DECISION NOTICE
CHANGE APPLICATION
Planning Act 2016 s 83

Change Application – Renewable Energy Facility – Gleesons Road, Jensens Road, Robinson Road and Freestone Road, Sladevale

The change agreed to is the amendment of Conditions 9 and 10 of Schedule 1.

client	TERRAIN SOLAR		
project name	WARWICK SOLAR FARM		
project location	GLEESONS ROAD, SLADEVILLE, QLD		
title	LANDSCAPE VIEW STUDY		
not to scale	AS SHOWN		
document number	136472-5 -	L-0-01 -	E
project		drawing	revision
northpoint

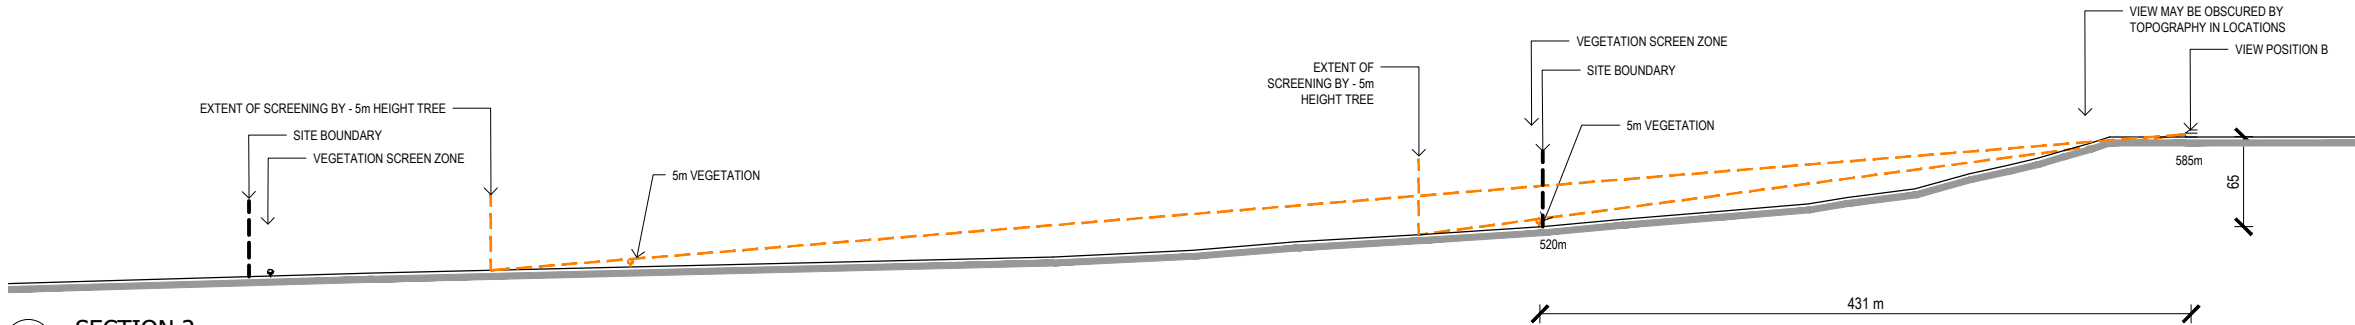
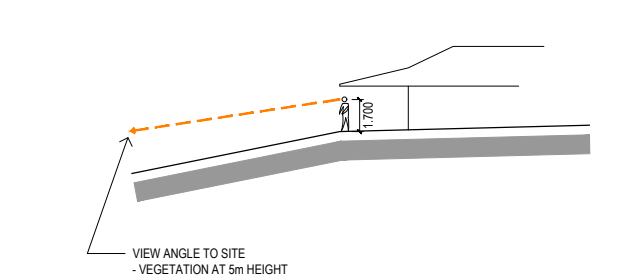
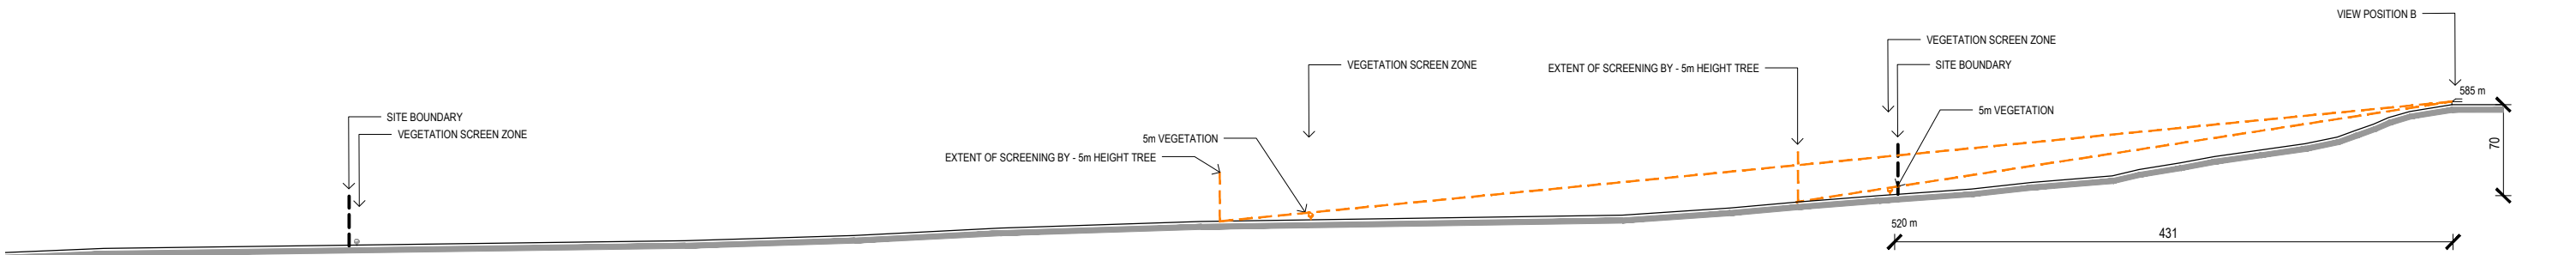
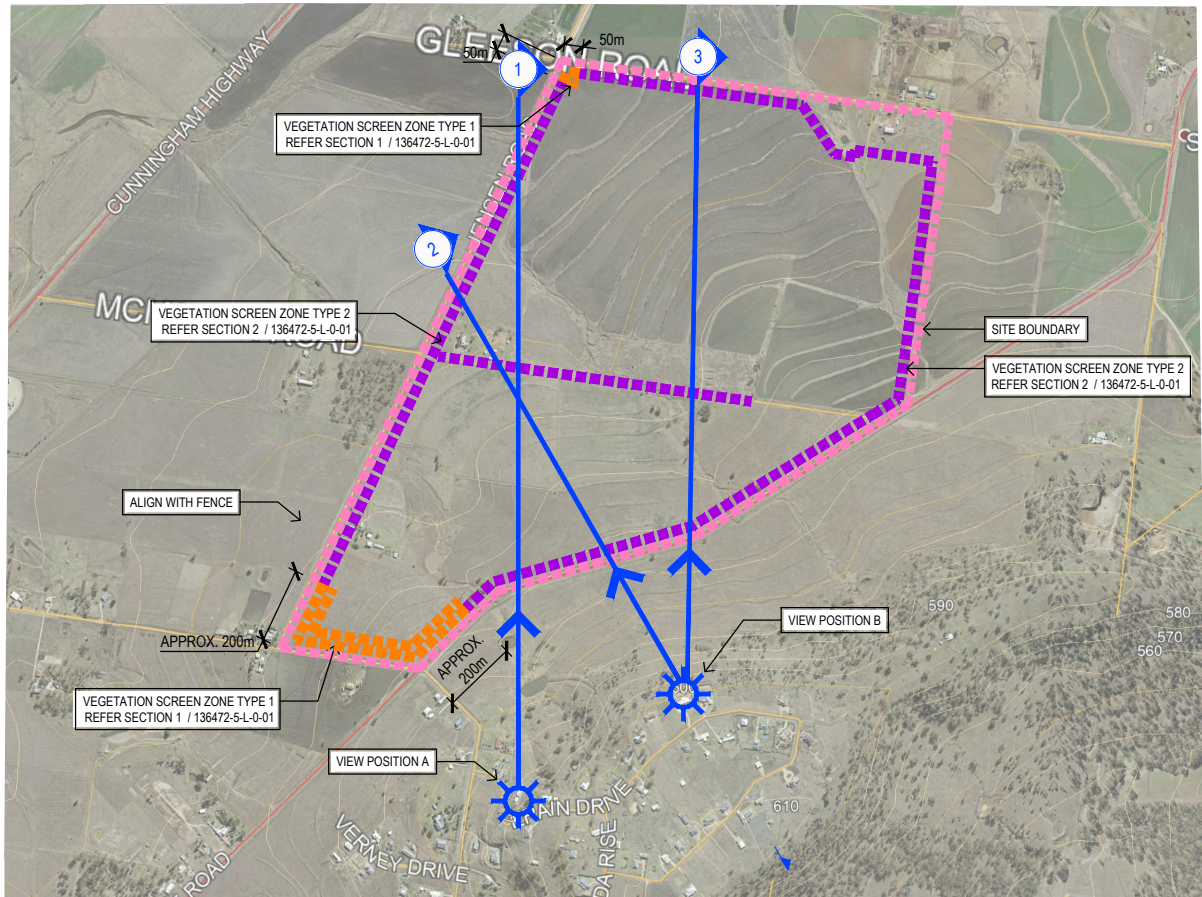
4. No solar panels are to be erected within the interface areas around the site in accordance with the Site Layout Plan (136472-01-A) and Landscape View Study (136472-5-L-0-01 Revision E and 136472-5-L-0-02 Revision B). Within the interface area, random plantings of a variety of native trees and shrubs of differing growth habits are to be provided. The trees and shrubs must be of species that are fast growing, frost resistant and drought hardy. The vegetated buffer around the periphery of the site is to be maintained so it provides an effective visual buffer.

22. A security fence shall be erected within the site in accordance with the Landscape View Study Plan (136472-5-L-0-01 Revision E and 136472-5-L-0-02 Revision B). **Details of the proposed fencing are to be submitted to and approved by the Director Planning, Environment and Corporate Services prior to construction of the fencing commencing.** Fencing is to be provided and maintained in accordance with the approved details.

23. Landscaping is to be provided in accordance with the Landscape View Study Plan (136472-5-L-0-01 Revision E and 136472-5-L-0-02 Revision B) consisting of:

- (a) in the 60 metre wide interface area: a 20 metre wide landscape strip and a 40 metre infrastructure buffer; and
 - (b) in the 20 metre wide interface area: a 10 metre wide landscape strip and a 10 metre infrastructure buffer.
